### $\frac{\textbf{MONTGOMERY COUNTY HISTORIC PRESERVATION COMMISSION}}{\textbf{STAFF REPORT}}$

Address: 5918 Cedar Parkway, Chevy Chase Meeting Date: 10/23/2024

**Review:** 1088225 **Staff:** Dan Bruechert

**Proposal:** Hardscape Alteration for outdoor fireplace construction, grill island, post installation,

> **GRILL ISLAND DETAILS**

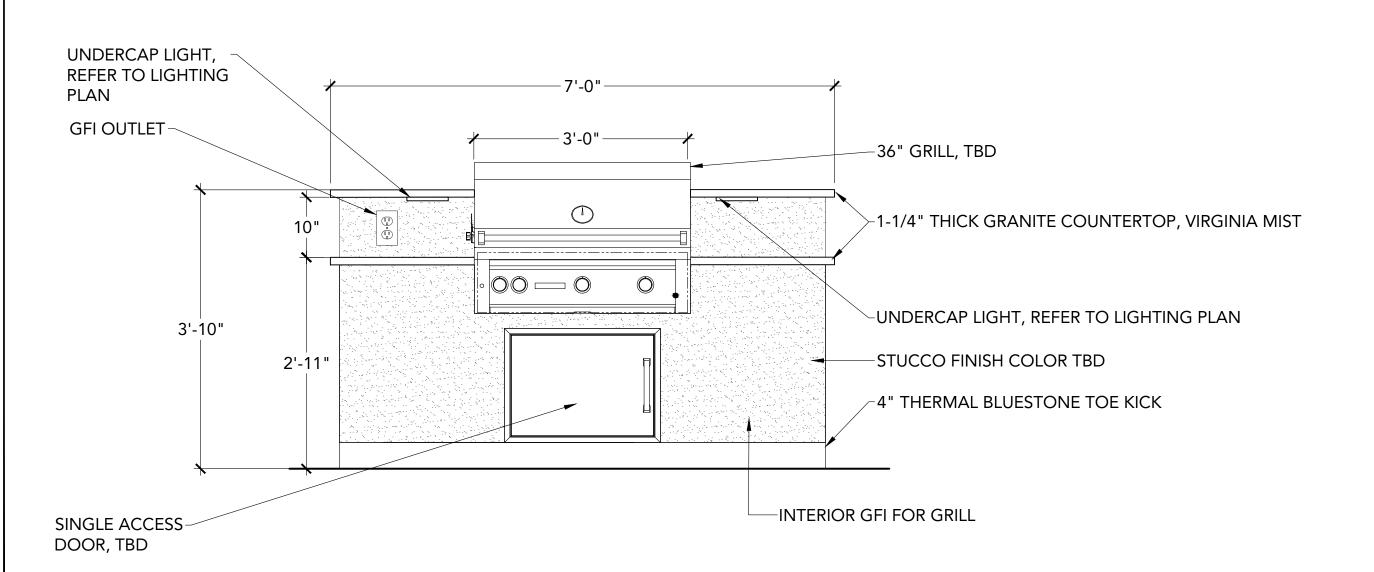
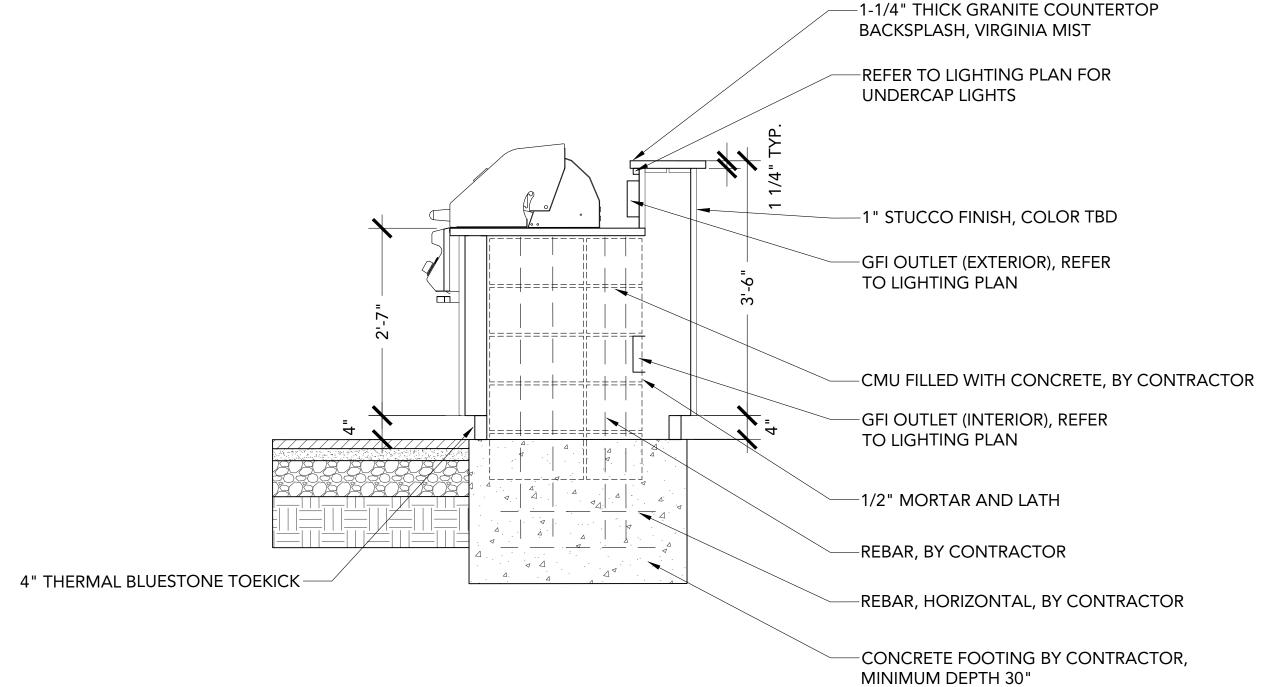
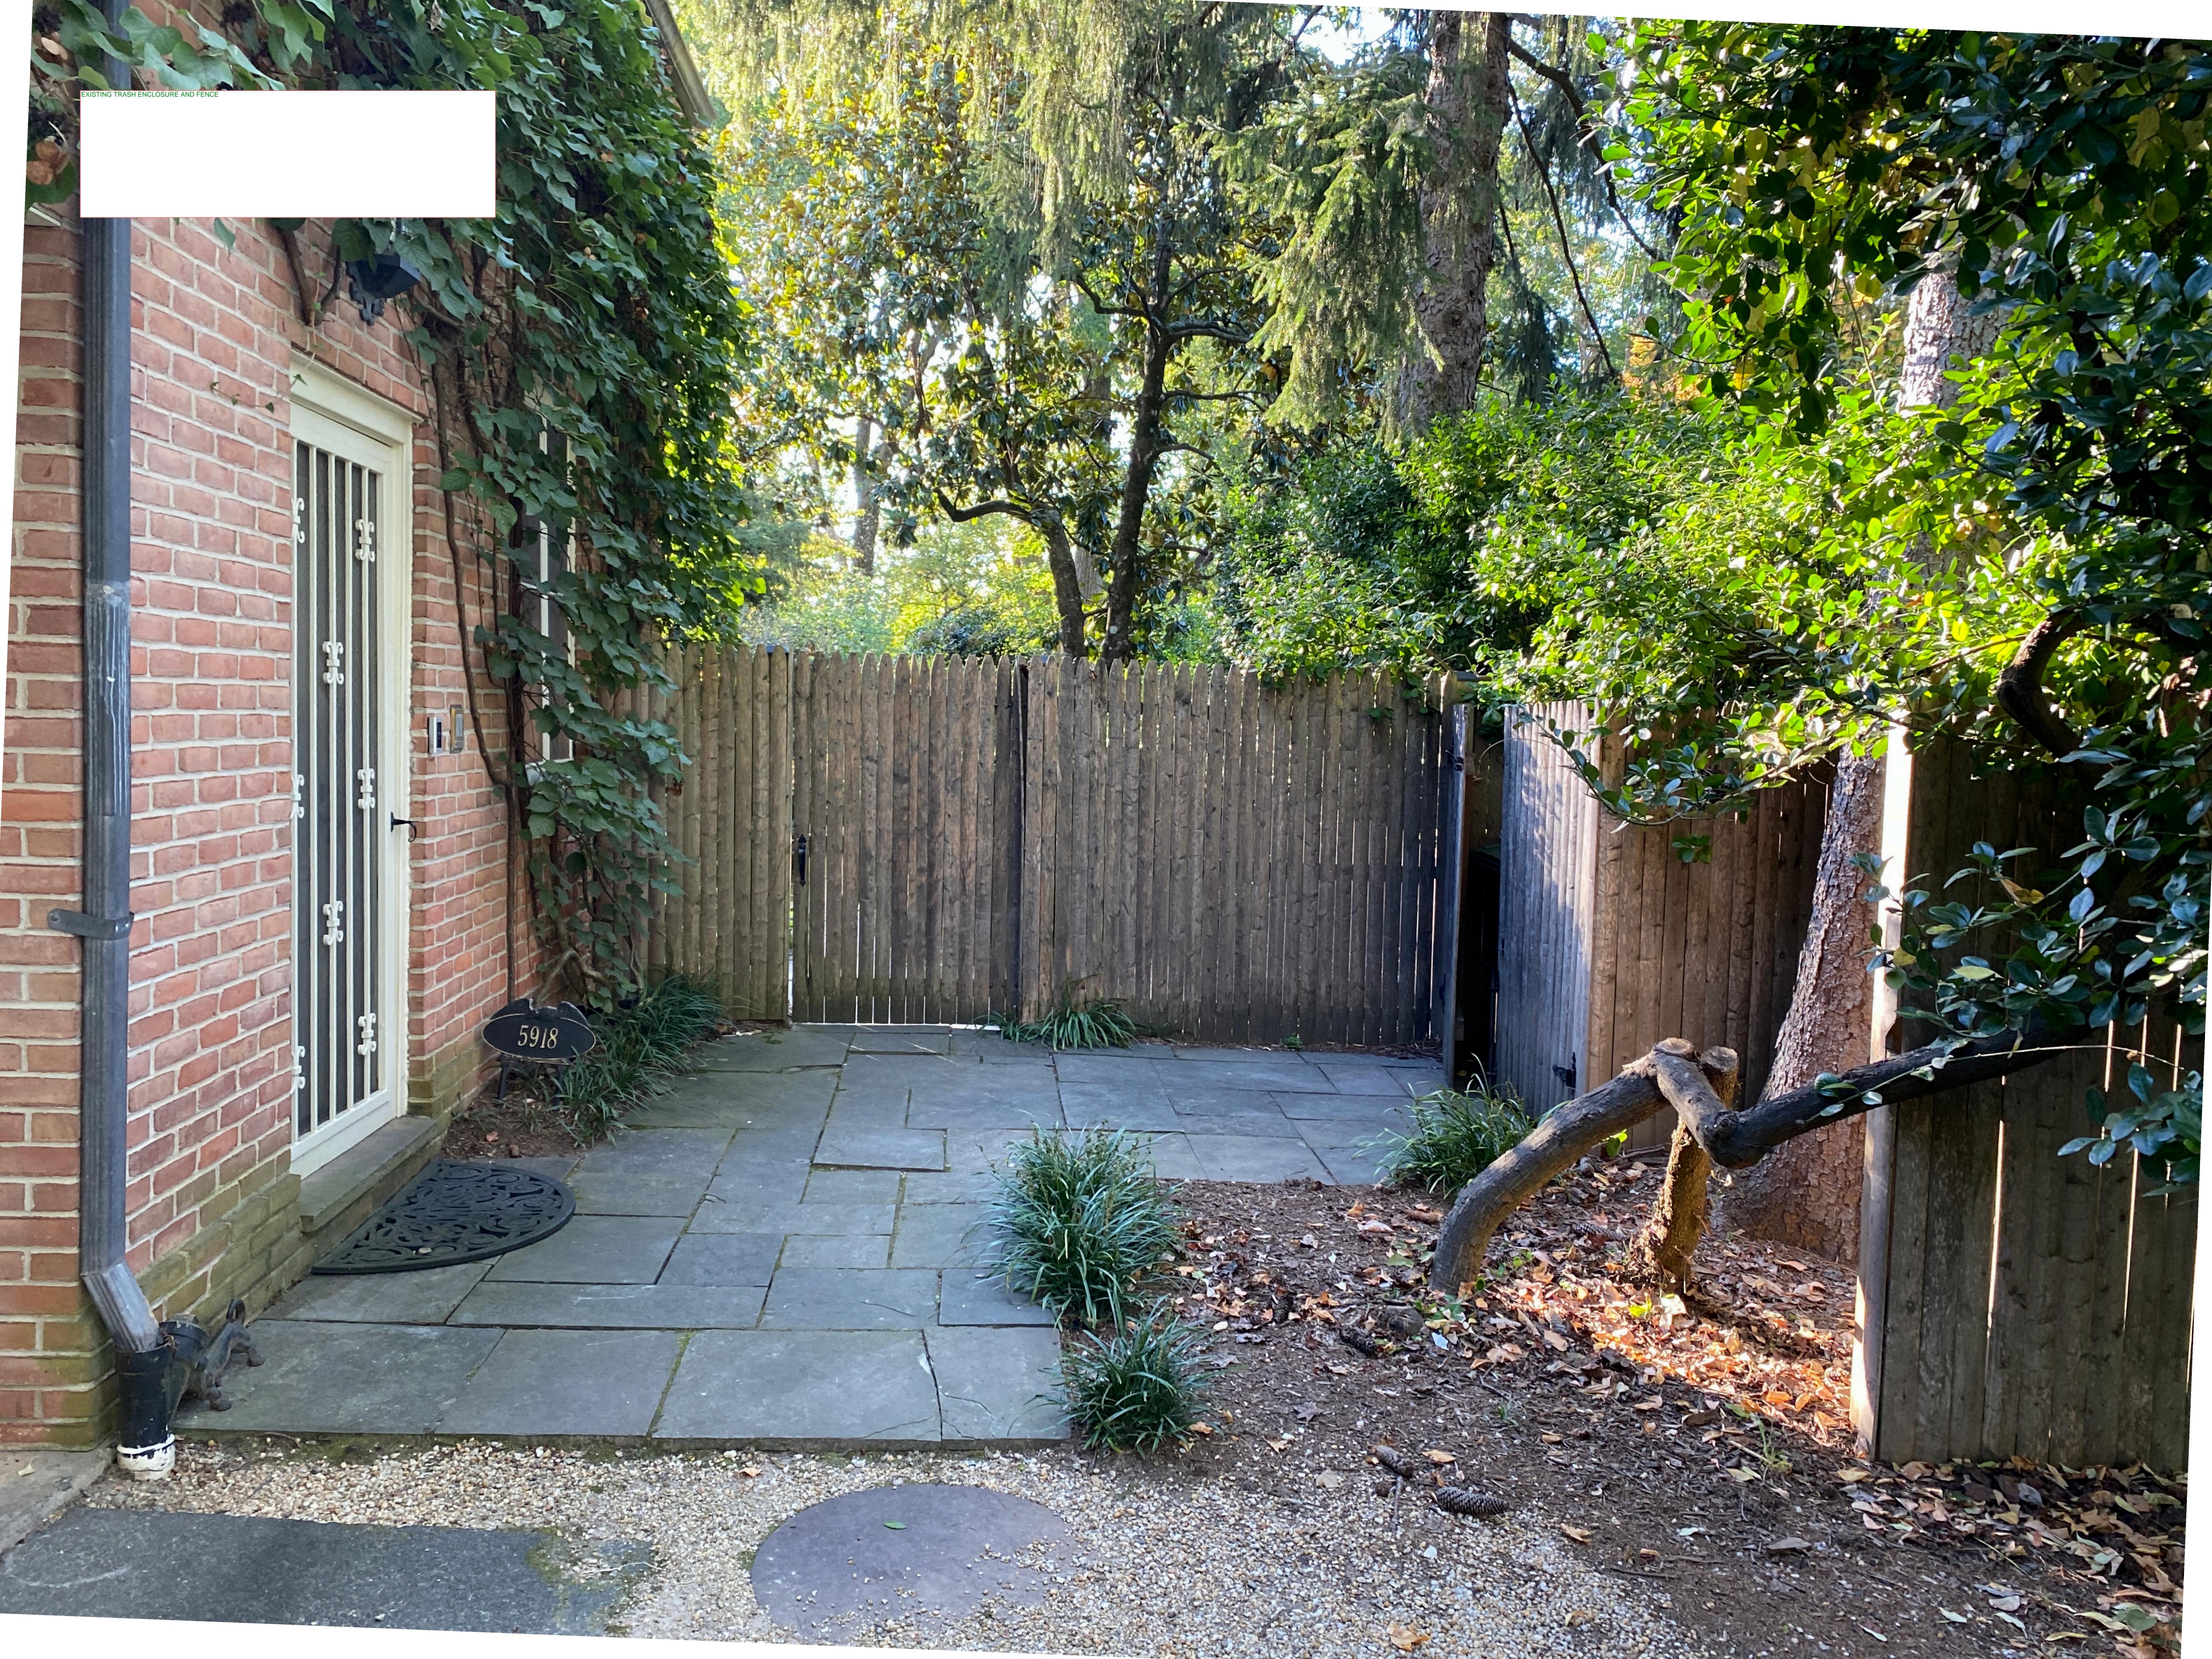
To the northwest of the house, adjacent to the existing patio, the applicant proposes to construct a grill island. The proposed feature includes a grill and adjacent storage cabinets. The stucco finish is intended to mimic the stucco on the house and the proposed fireplace, as discussed above. Staff finds this feature should be reviewed as a "garden structure" that is not visible from the public right-of-way and should be reviewed under lenient scrutiny. Staff finds the proposed grill island will not detract from the character of the site or surrounding district and recommends the HPC approve the structure under the *Design Guidelines*, 24A-8(d), and Standards 2 and 10.
